REPAIR LAKE POWELL  
 DAM & SPILLWAY  
 JAMES CITY CO.  
 VIRGINIA  
 APPLICATION BY:  
 FLORENCE ADEIT

**SKETCH - LAKE POWELL SPILLWAY**

SECTION A-A  
 NOT TO SCALE

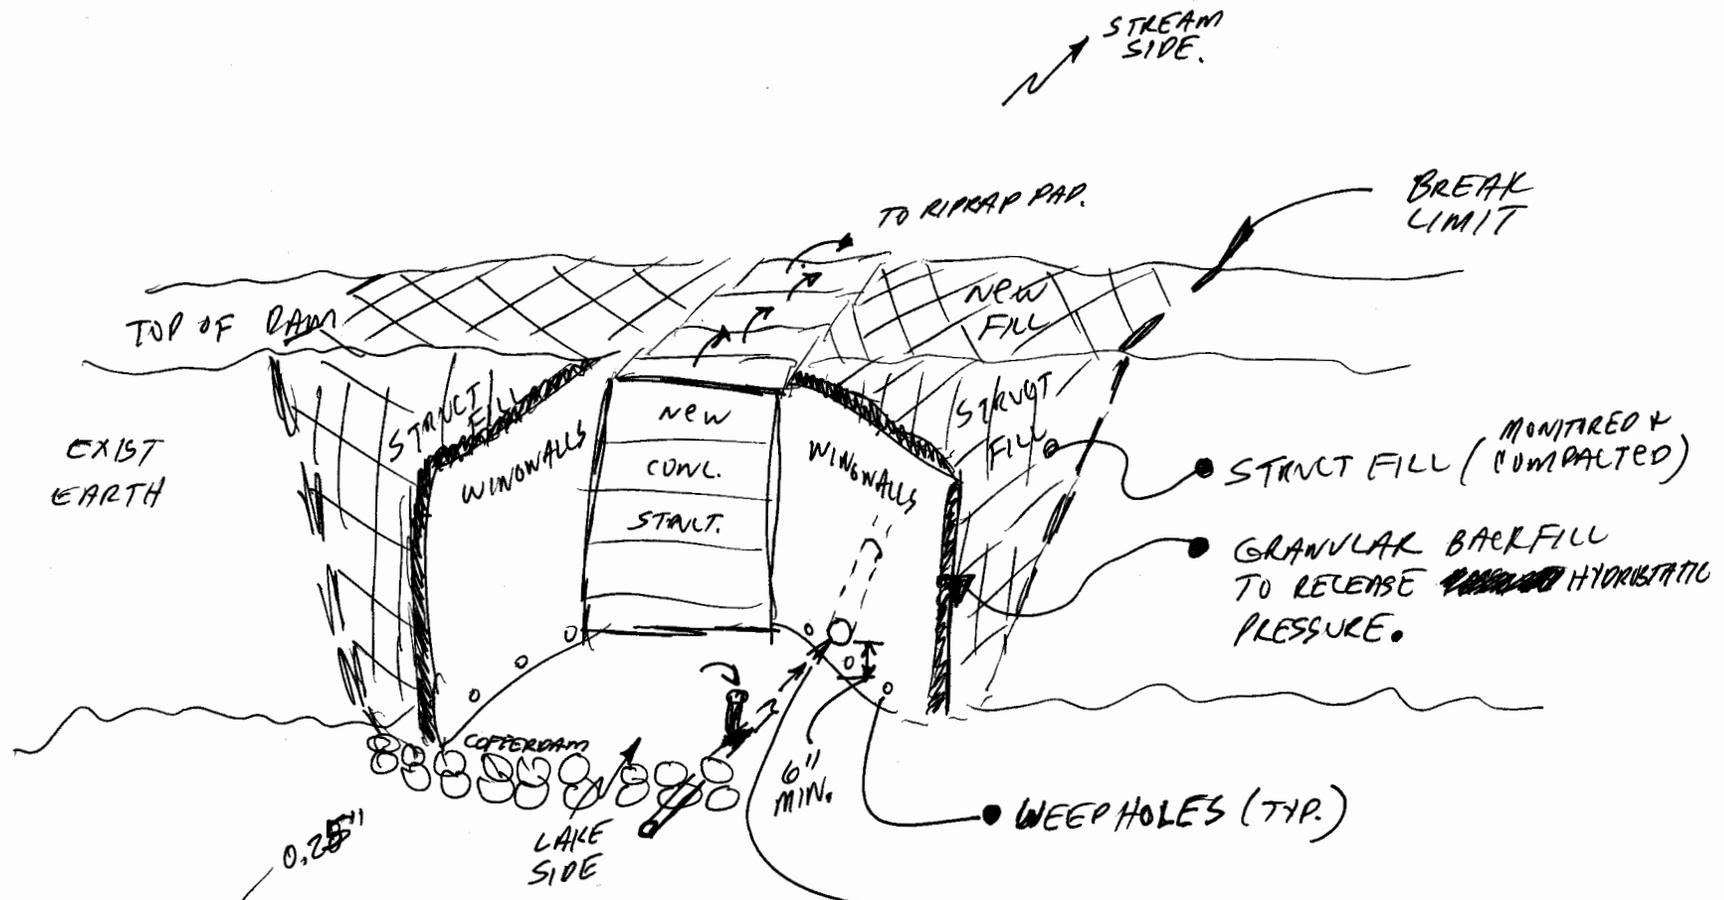
Concrete? How thick?  
 Reinforced?

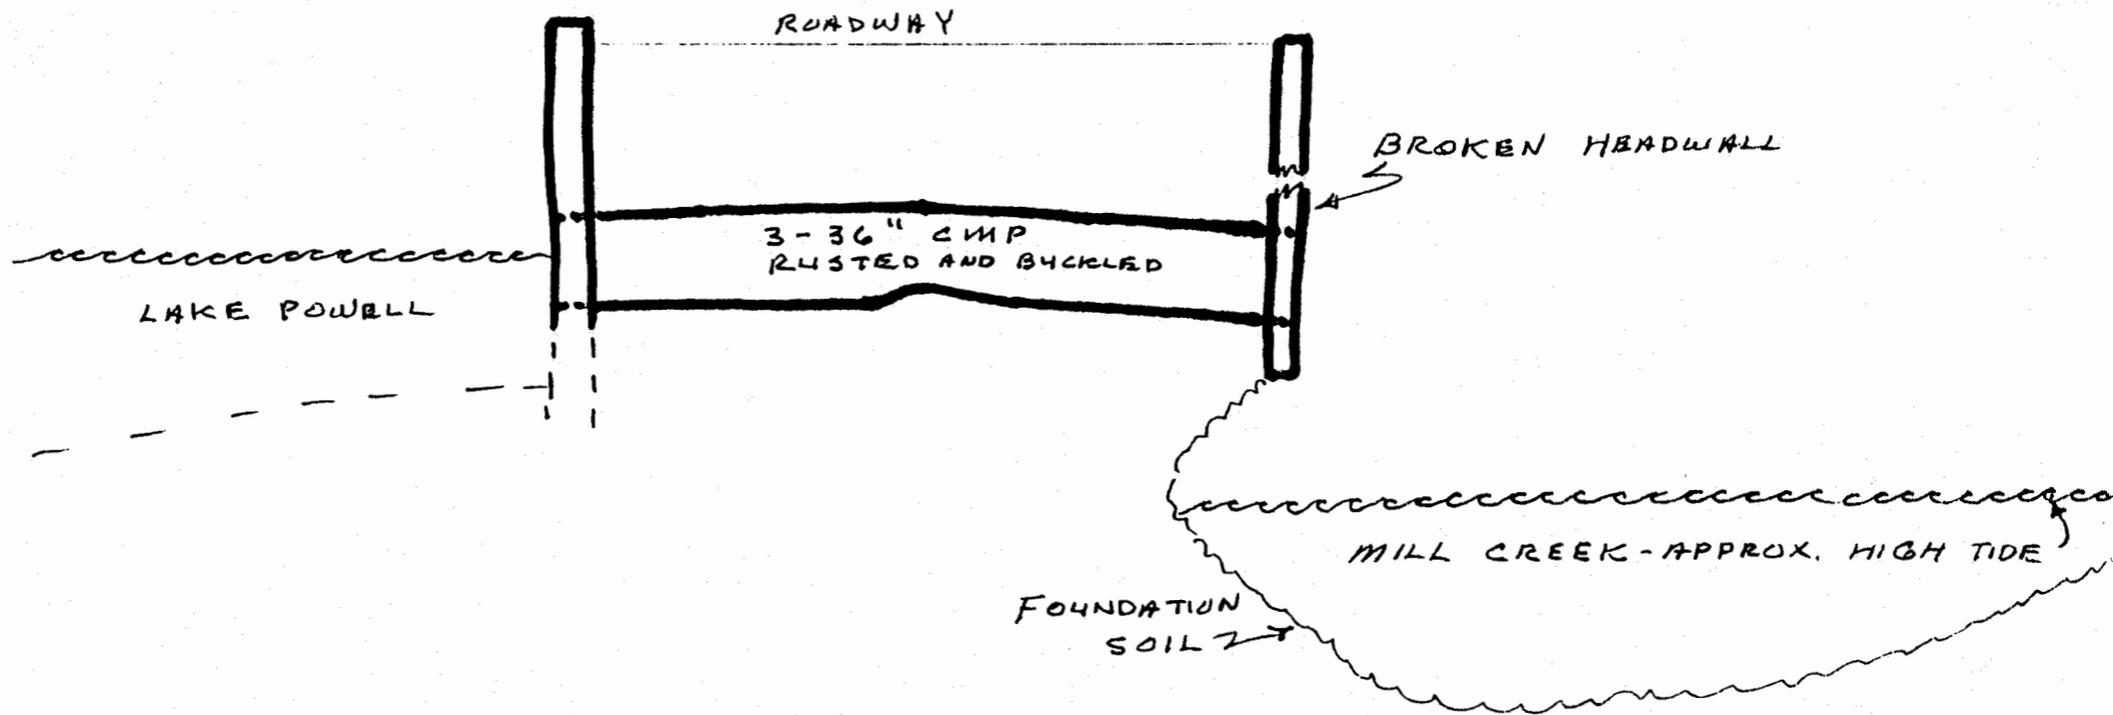
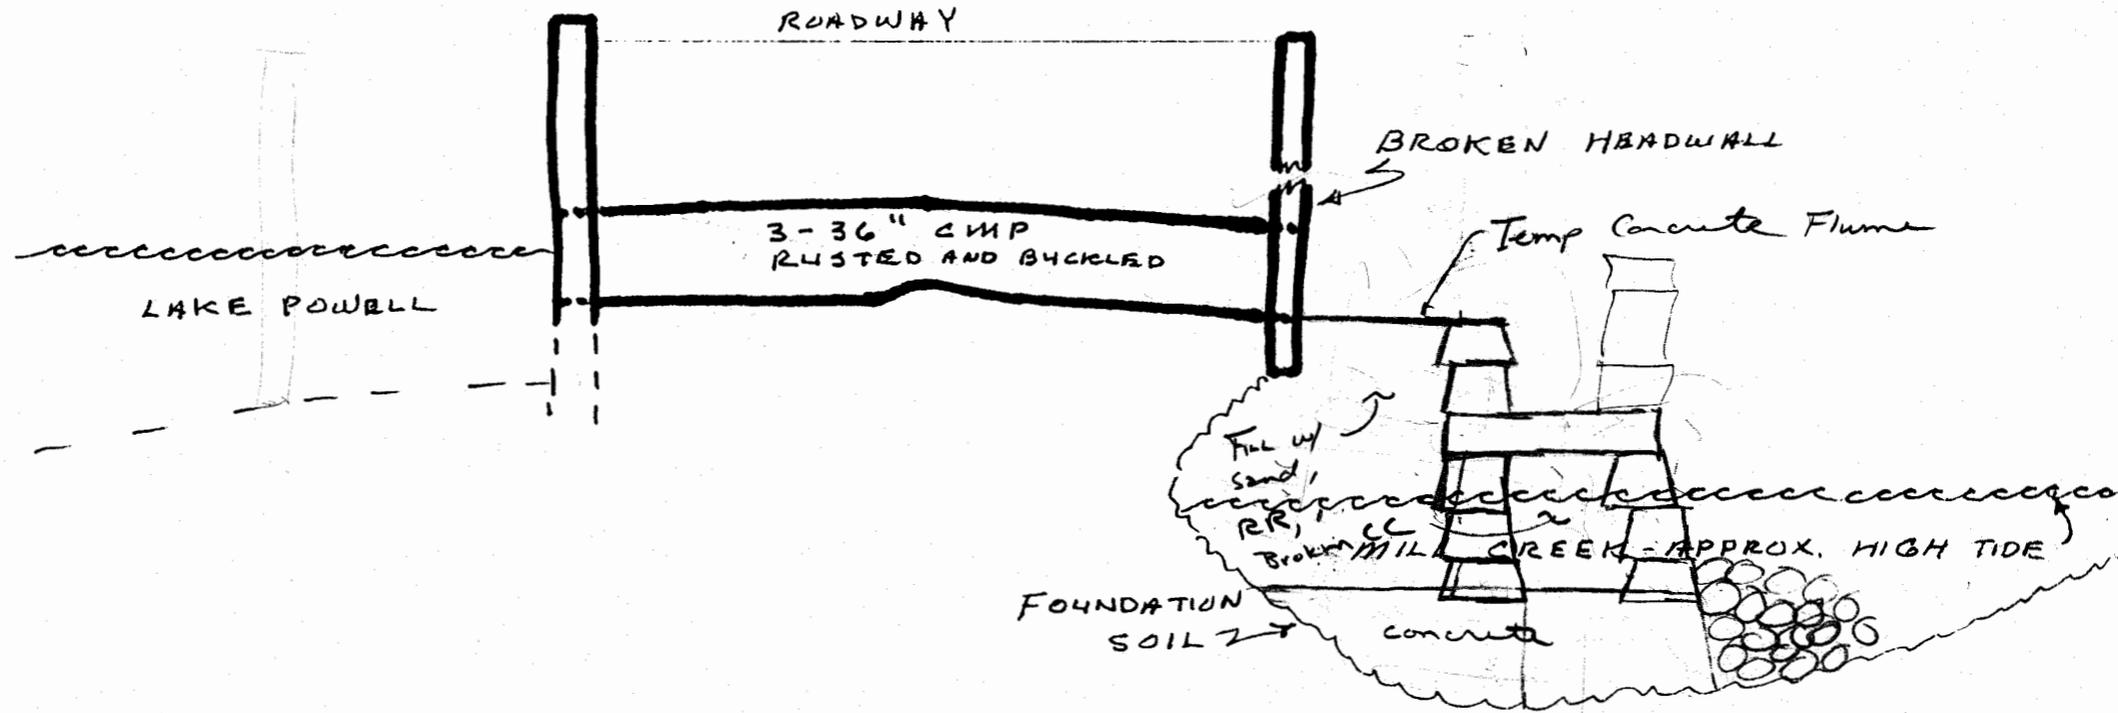
H.R. Dellinger - 820-5122 keeper  
- does design need to be certified by P.E.
